**Landscape and Visual (L&V) Monitoring Report for
Harbour Area Treatment Scheme Stage 2A
(Operational Phase) (November 2022)**

Report No.: OT_2022015

Landscape and Visual Impact Assessment Checklist for Site Audit – North Point PTW

Landscape and Visual Impact Assessment Checklist for Site Audit –Central PTW

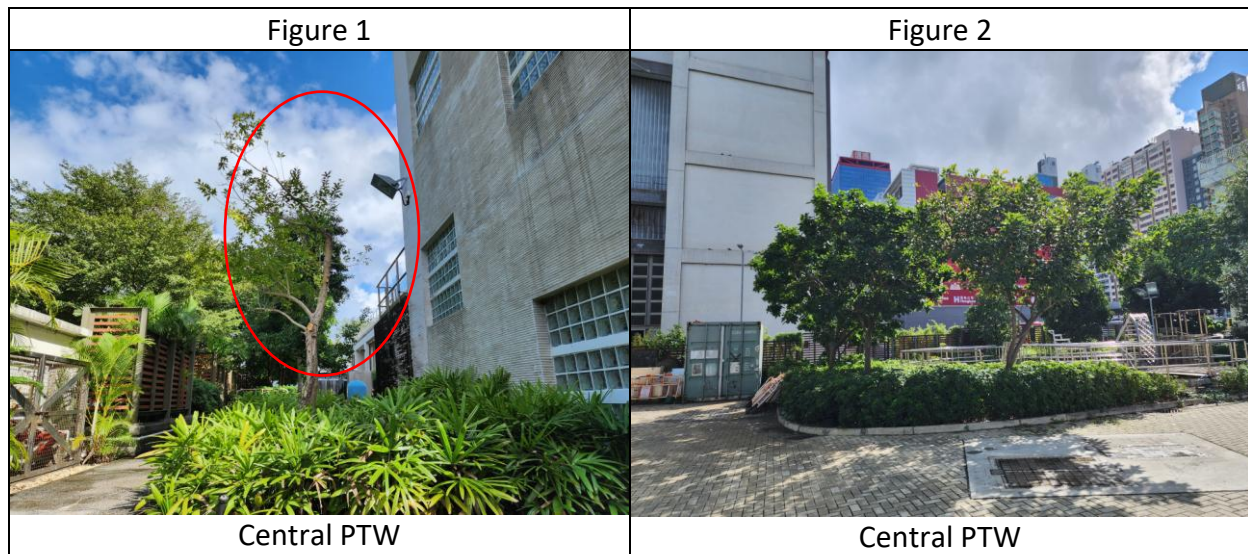
1. Noticed the dead branches of the tree at entrance area have been removed (Figure 1).

Landscape and Visual Impact Assessment Checklist for Site Audit – Sandy Bay PTW

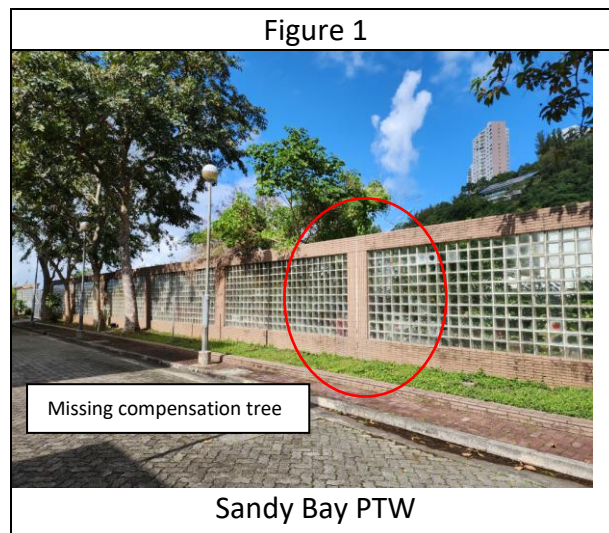
1. Follow up rectification item no.1 on 29/07/2022, the marked tree was removed but the compensation tree is missing. The Contractor is reminded to carry out tree replacement.

Landscape and Visual Impact Assessment Checklist for Site Audit – Cyberport PTW

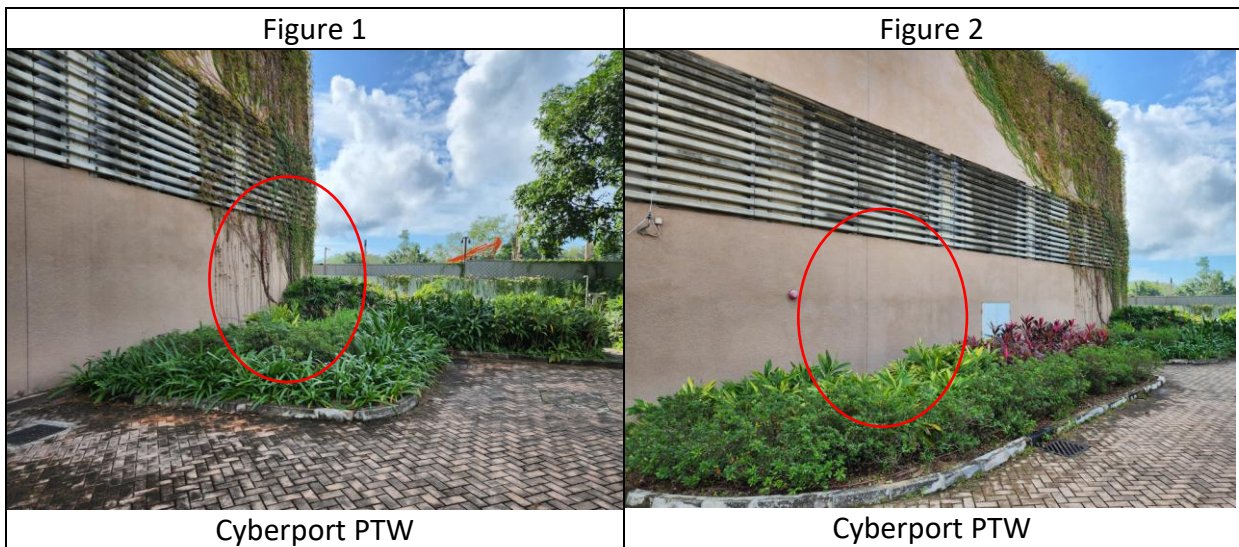
1. Noticed the dead tree of observation item on 26/09/2022 inside the planting area have been removed (Figures 1 & 2).

1. The contractor is recommended to replant the trees as early as possible for compensating the removal of dead tree

Landscape and Visual Impact Assessment Checklist for Site Audit –Ap Lei Chau PTW

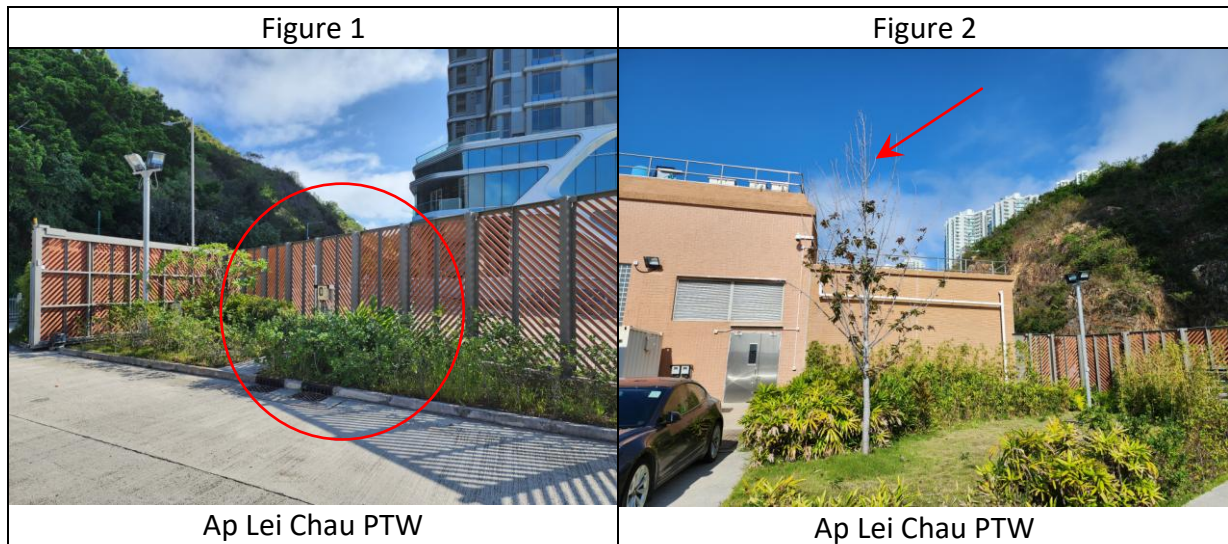
1. Noticed the dead tree of observation item on 29/08/2022 at the entrance area has been removed (shown in Figure 1).

1. Follow up observation item no. on 26/10/2022, die back on twigs was observed at entrance area (shown in Figure 2). It is recommended that maintenance party to provide trimming to the dead twigs.
2. The contractor is recommended to replant the trees as early as possible for compensating the removal of dead tree

Landscape and Visual Impact Assessment Checklist for Site Audit – Stonecutters Island PTW

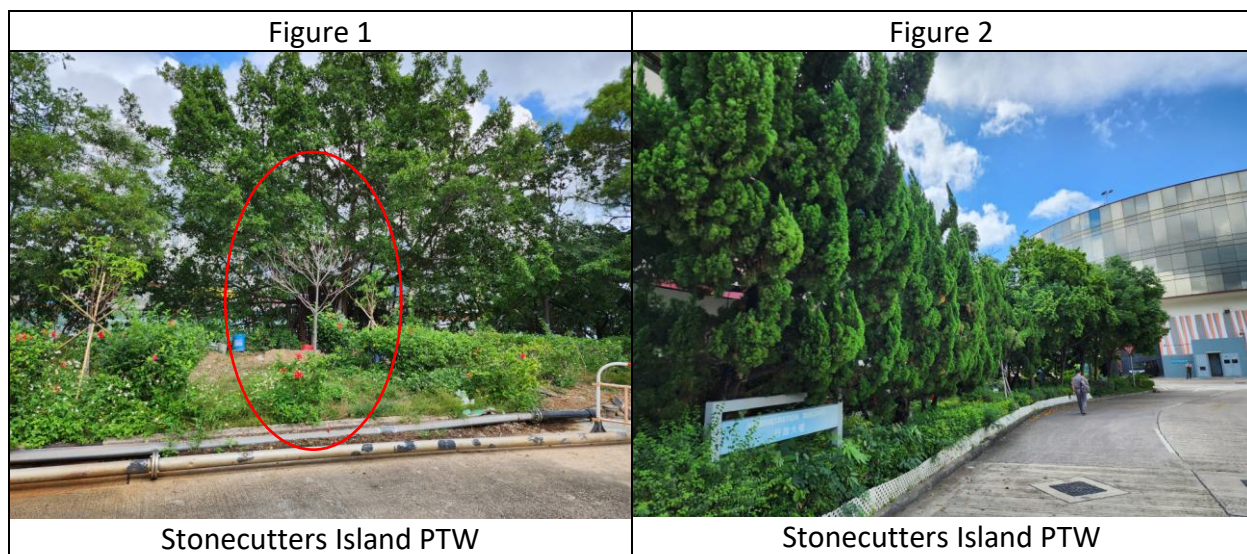
1. Follow up observation item no. 1 on 29/08/2022, Poor health is observed for replacement tree (shown in Figure 1). It is recommended that maintenance party to review if replacement is required.
